2nd Further Information

**Proposed Temporary Warehouse (excluding Dangerous Goods Godown)
with Ancillary Facilities and Associated Filling of Land for a Period of 3 Years in "Agriculture" Zone,
Lots 136 RP (Part) and 2149 (Part) in D.D. 106 and Adjoining Government Land,
Kam Tin, Yuen Long, New Territories**

(S.16 Planning Application No. A/YL-KTS/1107)

Response-to-Comment (RtC)

DWG. TITLE
 SIGHTLINE ANALYSIS

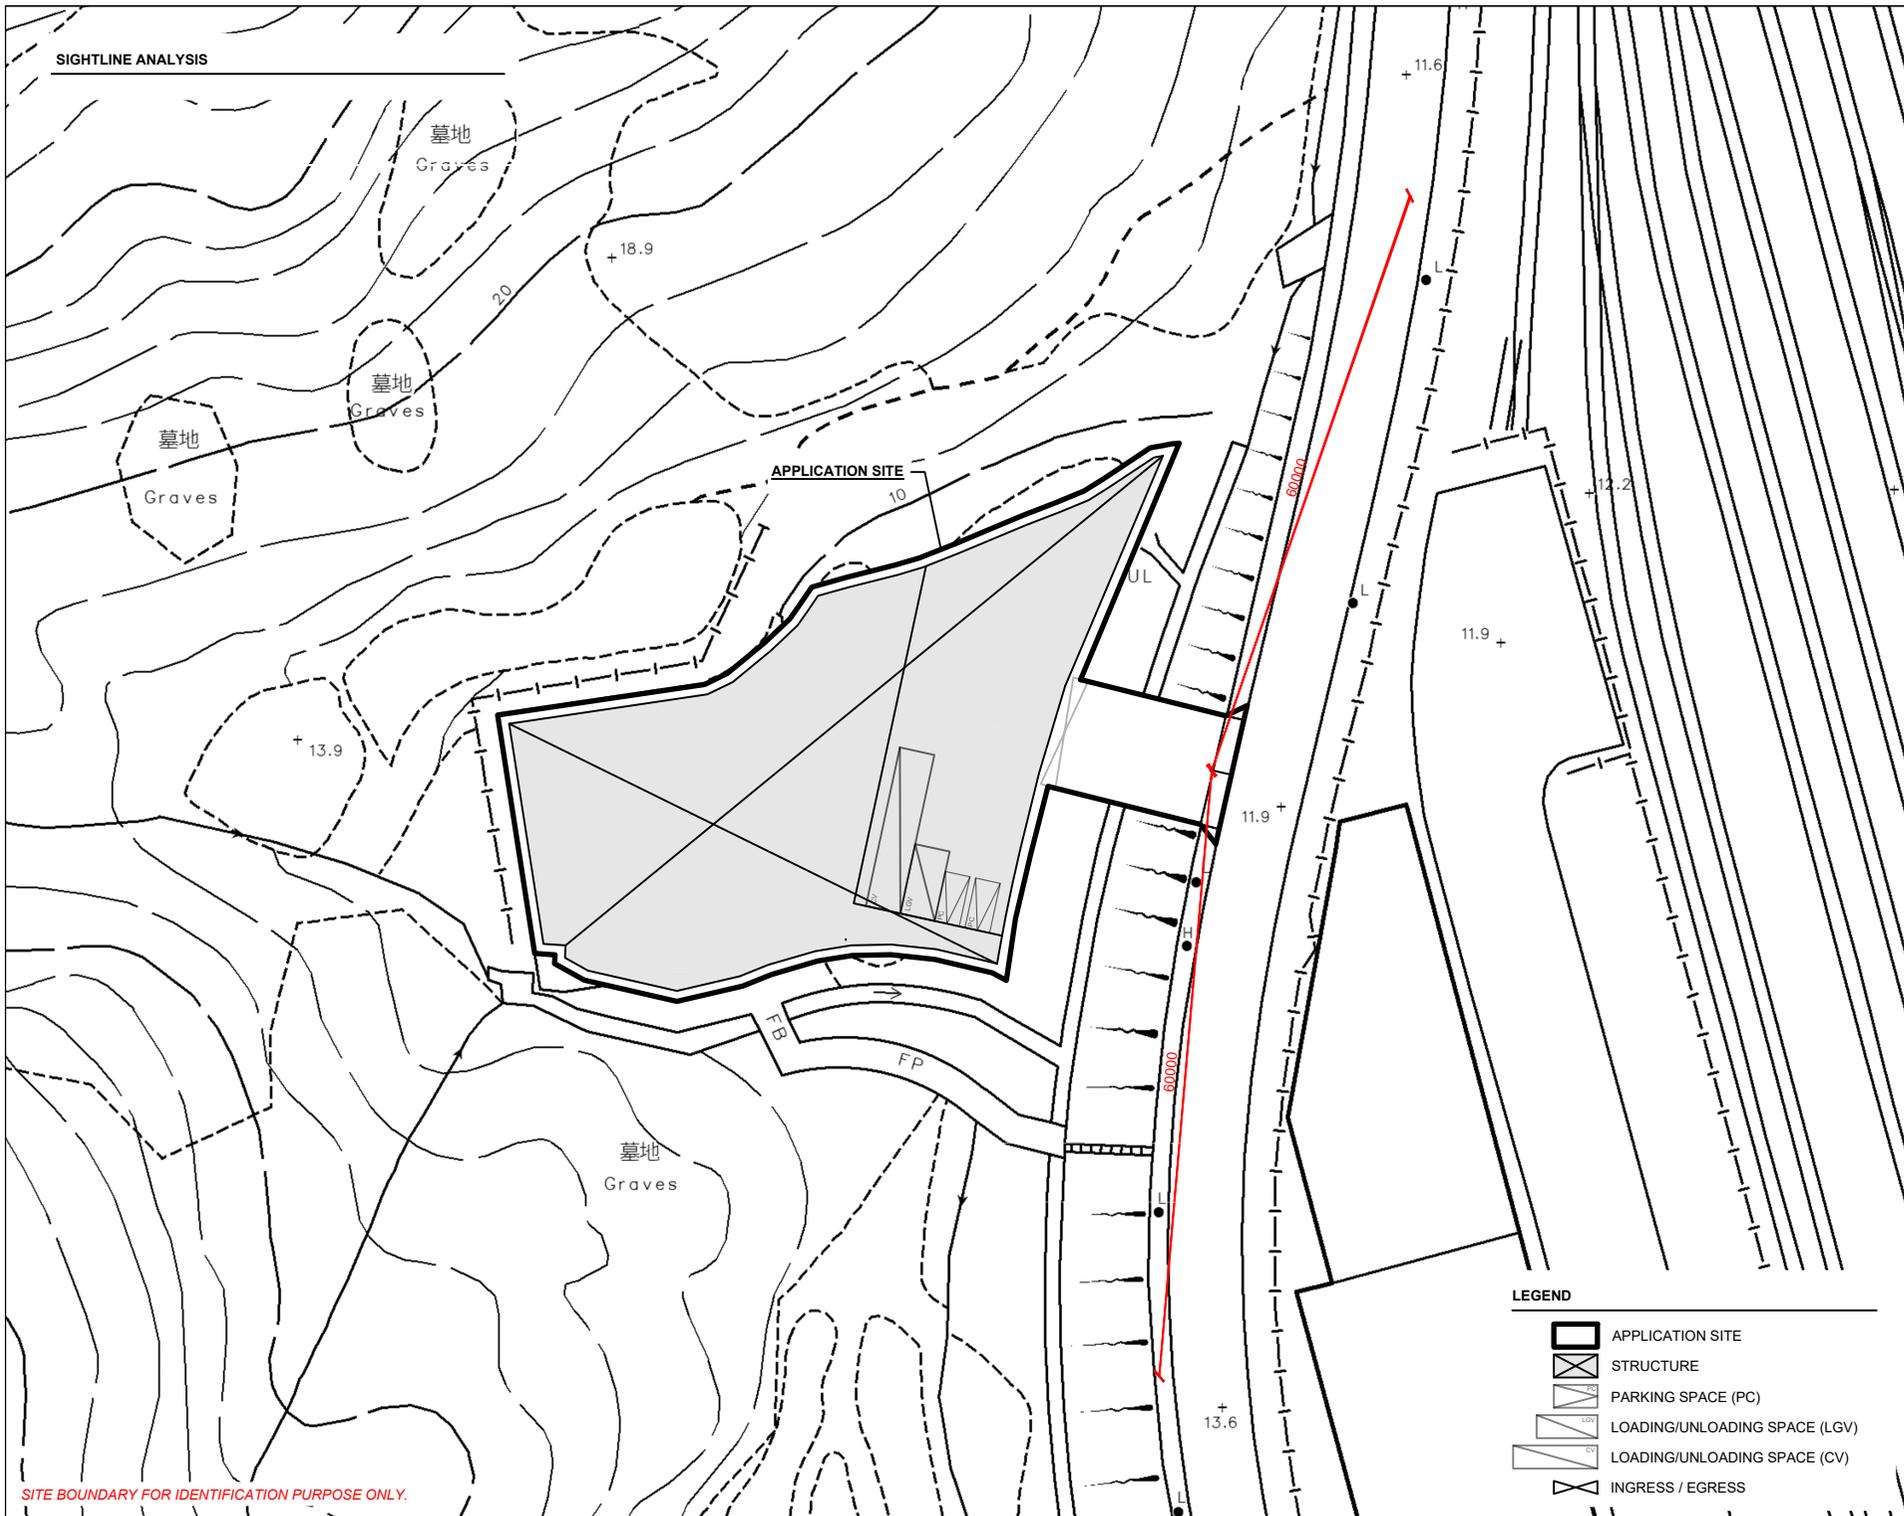
(b)	The applicant should provide sightline analysis at the run-in/out.	According to the sightline analysis enclosed at Annex 1 , adequate visibility with a minimum of 60 m is provided for vehicles at the run-in/out.
